<p>2022 KIMLEY-HORN AND ASSOCIATES, INC. 2 North Nevada Avenue Suite 300 Colorado Springs, Colorado 80903 (719) 453-0180</p>	<table border="1" style="width: 100%; border-collapse: collapse;"> <tr> <th>NO.</th> <th>REVISION</th> <th>BY</th> <th>DATE</th> <th>APPR.</th> </tr> <tr> <td> </td> <td> </td> <td> </td> <td> </td> <td> </td> </tr> </table>	NO.	REVISION	BY	DATE	APPR.					
NO.	REVISION	BY	DATE	APPR.							
<p>DESIGNED BY: MK DRAWN BY: RS CHECKED BY: KK DATE: 04/08/2022</p>											
<p>EAGLEVIEW EL PASO COUNTY, COLORADO OVERVIEW MAP - PBMP TRIBUTARY AREAS</p>											
<p>PRELIMINARY FOR REVIEW ONLY NOT FOR CONSTRUCTION</p>											
<p>PROJECT NO. 196288000</p>											
<p>SHEET</p>

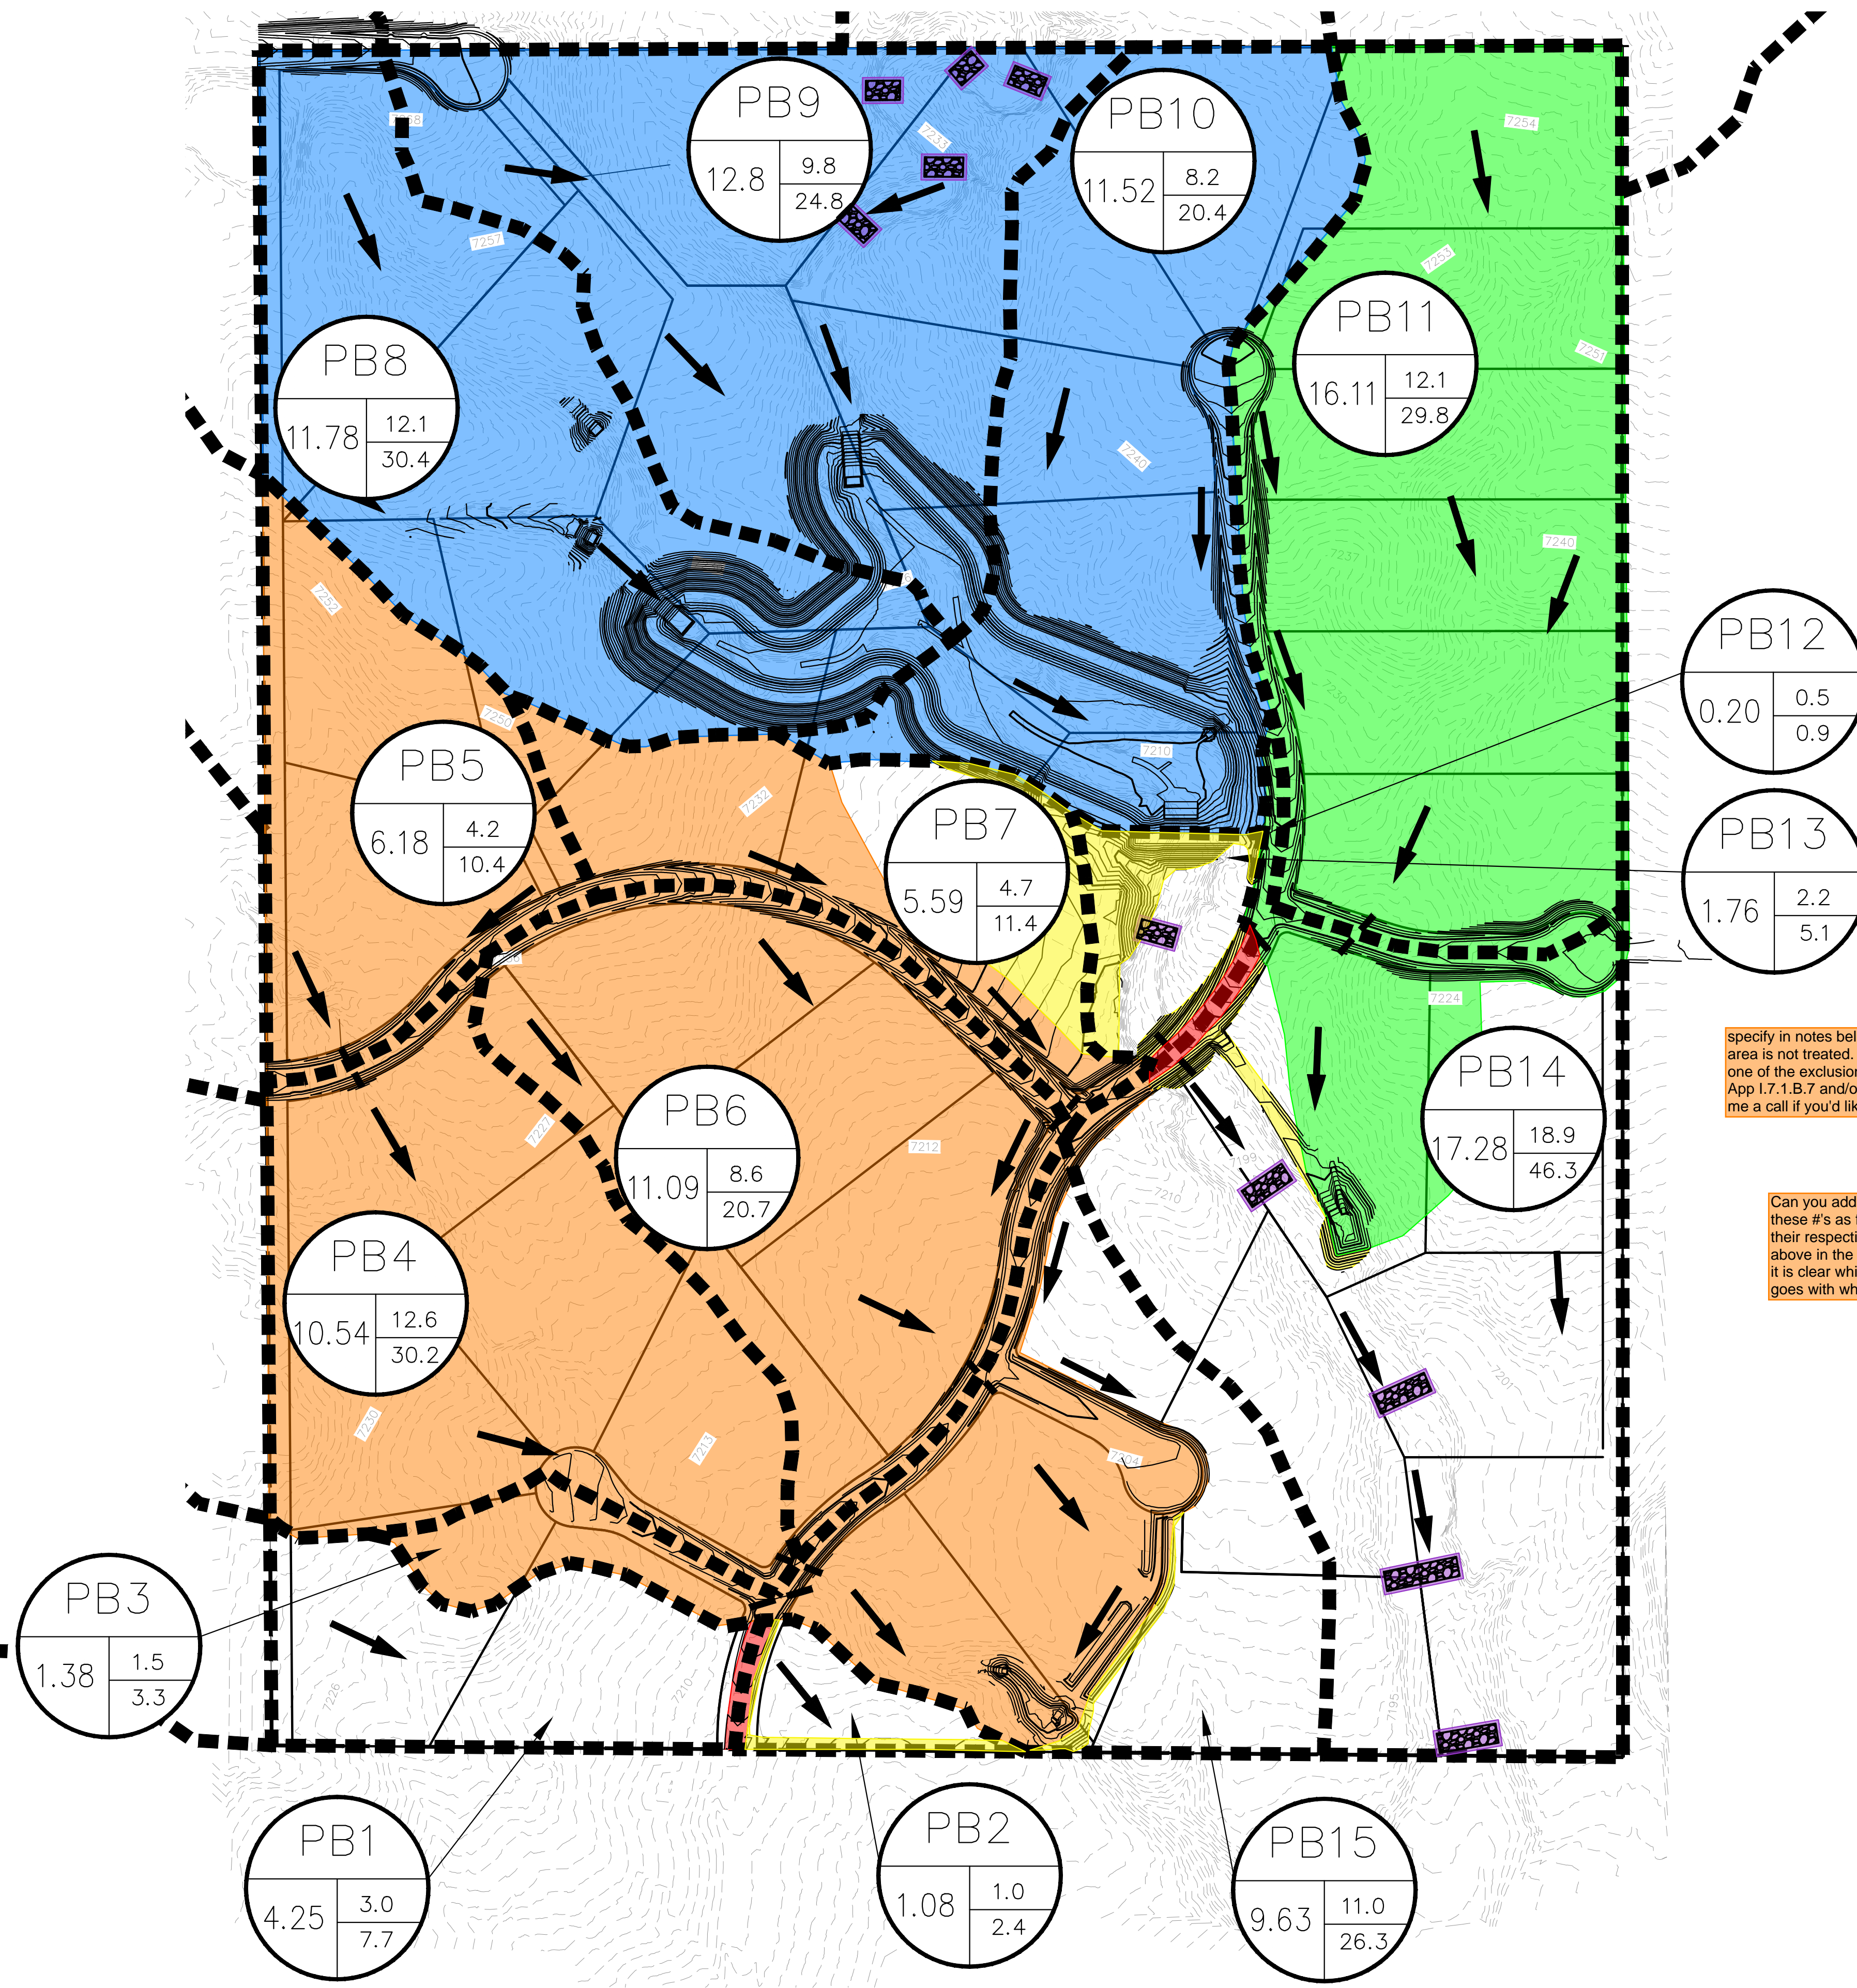
specify in notes below why this area is not treated. Likely per one of the exclusions in ECM App I.7.1.B.7 and/or B.8? Give me a call if you'd like to discuss.

Can you add each of these #'s as footnotes to their respective items above in the Legend so it is clear which note goes with which item?

The last # should be an "8" not a "5"
